Clayton Project No. 15-03095.14-006

**Subject: Response to USEPA Letter dated June 2, 2004  
Regarding Comments to ROST Investigation Report and Work Plan  
Hartford, Illinois – ILR000128249  
Illinois EPA# 1190505040 – Madison County**

PROPOSED MULTI-POINT  
VACUUM MONITORING PROBE  
LOCATION MAP

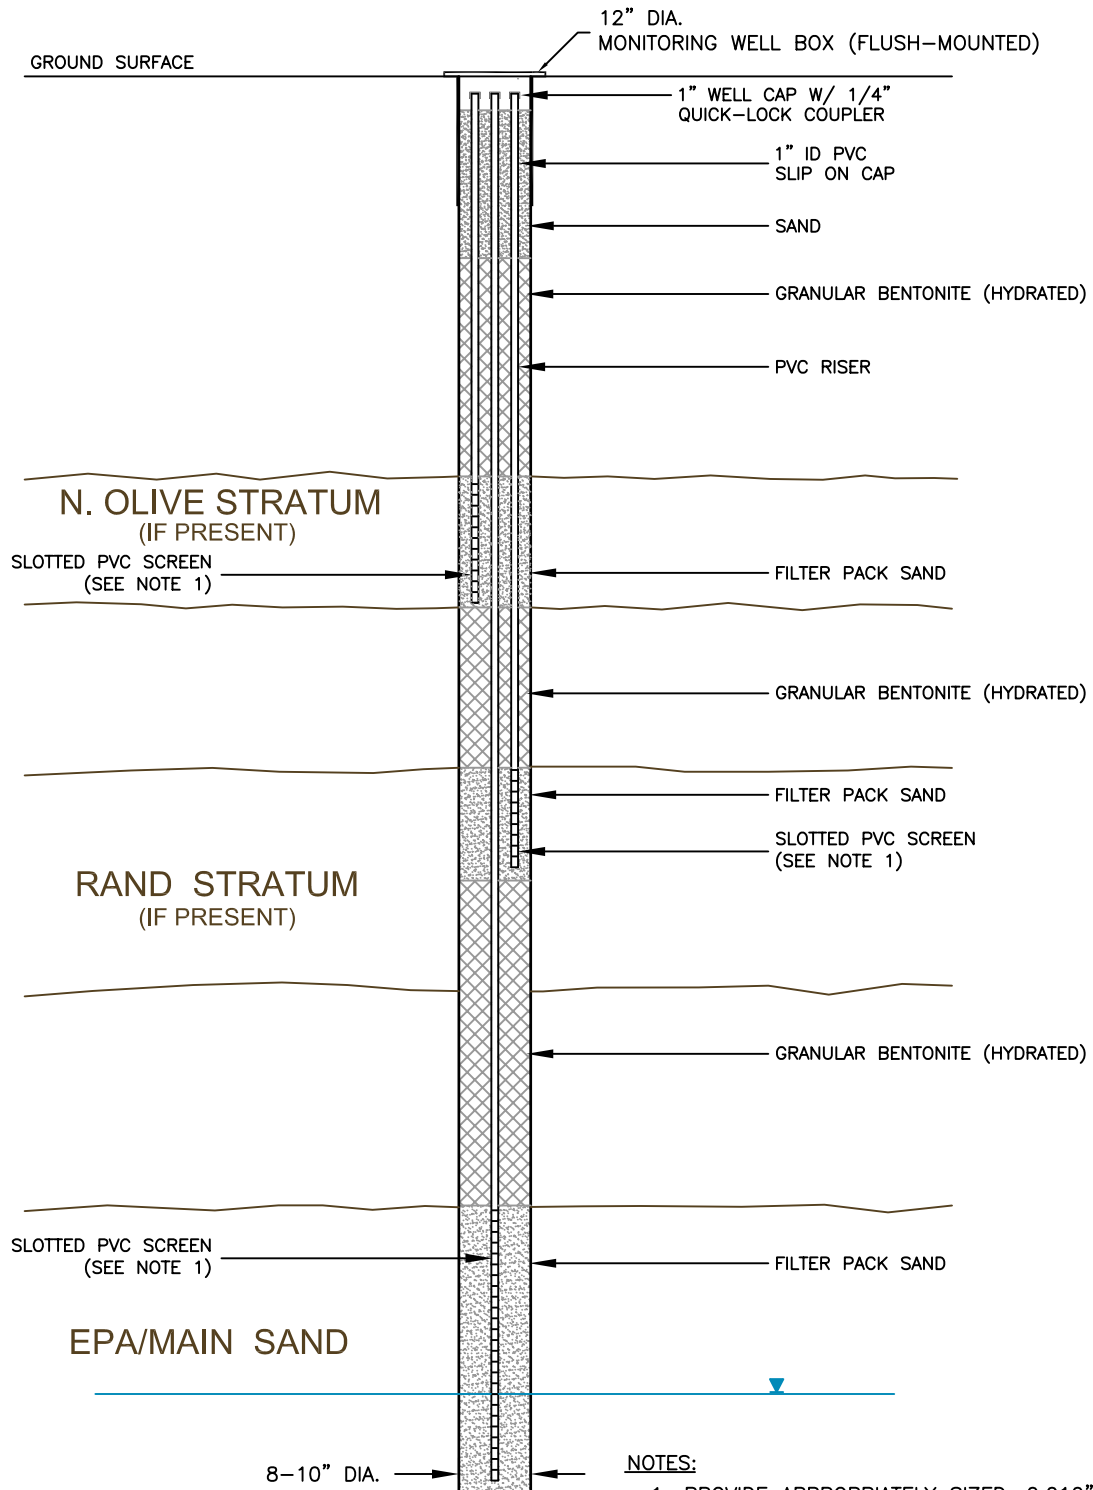
Comment #2

Additional piezometers should be added to determine seasonal variations in groundwater flow, to better understand basic and seasonal flow of groundwater, and ultimately provide information related to fate and transport of both perched and hydraulically connected contaminated, as-well-as consideration for NAPL fate and transport findings.

It is Clayton's opinion that with the installation of 30 multi-point vacuum monitoring points, set in various locations and stratum throughout the Village of Hartford, as originally proposed in Clayton's Technical Memorandum Vapor Control System Upgrade Design (Technical Memo), dated May 6, 2004, (see attached Figure 1) and as modified in this document based on a teleconference held between the Hartford Working Group and the Agencies on June 16, 2004, in addition to the installation of the 53 monitoring wells also set in various locations and stratum throughout Hartford, as identified in Figure 7-1 of the Investigation Report / Work Plan, that a sufficient amount of wells will be in place to provide a better understanding of basic and seasonal flow of groundwater within Hartford and surrounding areas. The attached Figure 1 replaces Figure 3-1 in the May 6, 2004 Technical memo.

TYPICAL MULTI-POINT VACUUM MONITORING PROBE  
CONSTRUCTION DETAILS  
(UNCONFINED CONDITIONS)

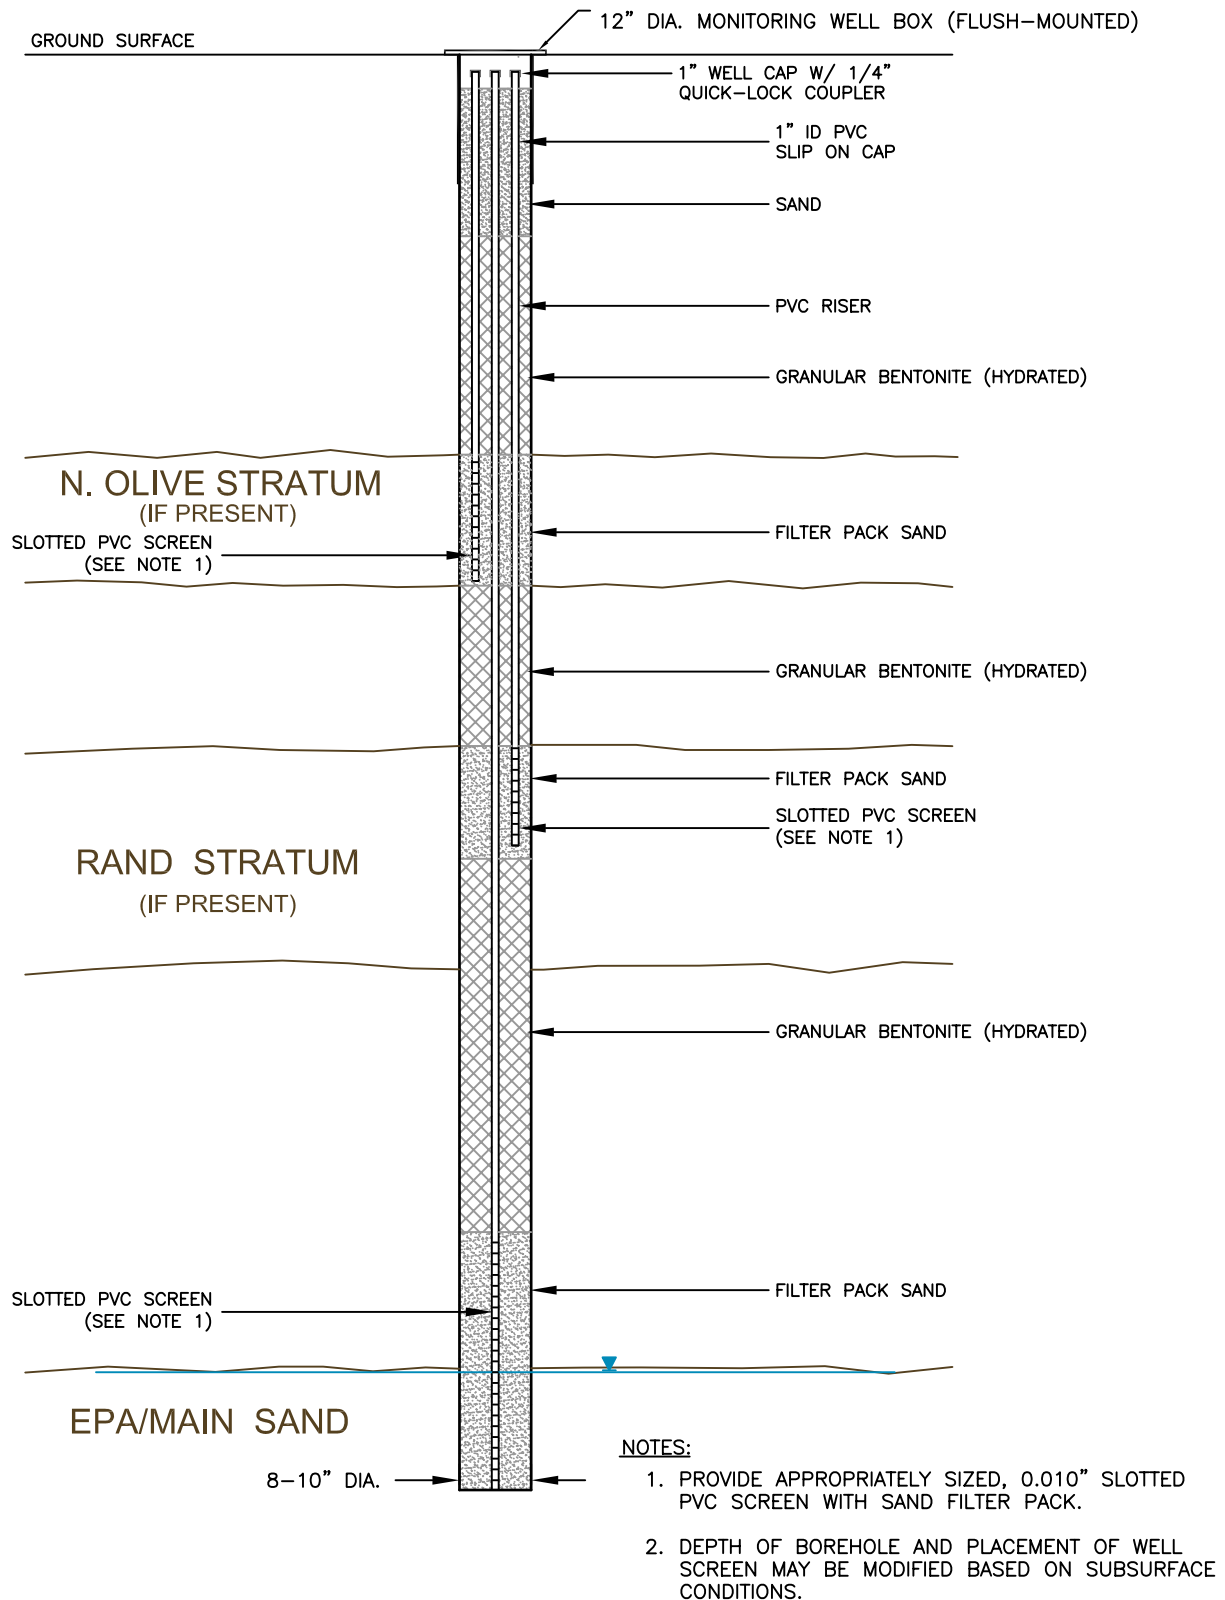
Comment #3

It is USEPA's understanding that the proposed wells inside the dashed line of Figure 7-1 are to be 4-inch wells and those outside the dash are 2-inch wells. The larger wells are being installed with the option to convert them to extraction wells if needed. Though the USEPA applauds the foresightfulness of this proposal, we are also concerned that there is not yet enough information to know if the proposed new wells inside the FPH would have the correct placement (both vertically and horizontally) to adequately remove subsurface product.

It is our opinion that the installation of piezometers or small gauge well clusters should be considered more before larger sized wells are installed. Small gauge well clusters or multiport wells can be used economically to further refine the CSM in support of product removal at the Site. These wells can be used in tandem with inexpensive field-based methods for the observation of contaminant behavior, which could facilitate a better understanding of the observed impact of river flocculations or the increase in odor related events.

In Clayton's opinion, enough information is known to allow for the correct placement and installation of new wells inside the FPH. However as discussed in the June 16, 2004 teleconference, we will proceed with the installation of the 30 multi-point vacuum monitoring points, as identified in the May 6, 2004 Technical Memorandum, (see attached Figure 1) prior to the installation of the 53 monitoring wells, as identified in Figure 7-1 of the Investigation Report / Work Plan. The information gained from the installation of these multi-point vacuum monitoring points will be evaluated to aid in the placement of the 4-inch wells within the area of free phase hydrocarbon. Minor

modifications to the multi-point vacuum monitoring points will be made to make them more suitable for water/product gauging. These modifications include increasing the size of the polyvinyl chloride (PVC) screens and risers from ¾-inch to 1-inch inside diameter, also (depending on the thickness of the stratum) varying the length of the multi-point screens from 1.0 foot to a more appropriate screen length, and in an unconfined condition increasing the depth of the monitoring point in the Main Sand to below the water table. (See attached Figures 2 and 3). The attached Figures 2 and 3 replace Figures 2-2 and 2-3 in the May 6, 2004 Technical Memo.
